**Service Action: Retrofit Heat Insulators to Turbocharger Coolant Lines**

F06 (M6)

F10 (M5)

F12 (M6)

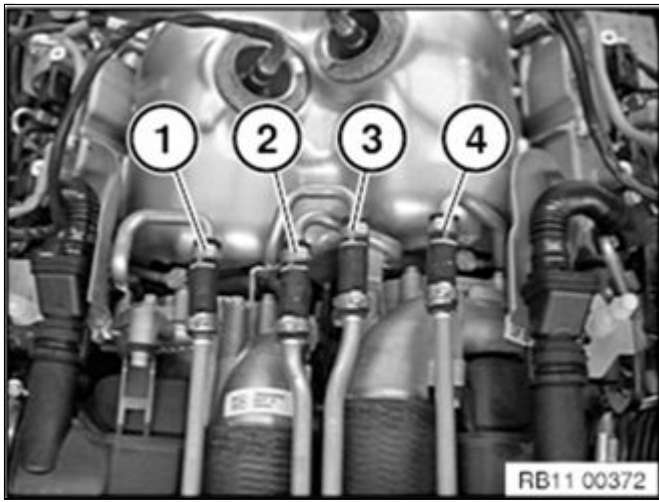
Check the coolant lines (1 through 4) at the turbochargers for any signs of leakage. Replace both the coolant

delivery line and coolant return line if there any leaks are found.  
Follow Repair Instruction RA 11 53 ...  
“Removing and installing/replacing coolant flow pipe and coolant return pipe for exhaust turbocharger (S63T 0) for coolant line replacement.”

Install insulator sleeves (1) on all four coolant lines as shown. Insulator sleeves are to be installed on the original coolant lines (no leaks found) or after replacing the coolant lines (leaks were found).
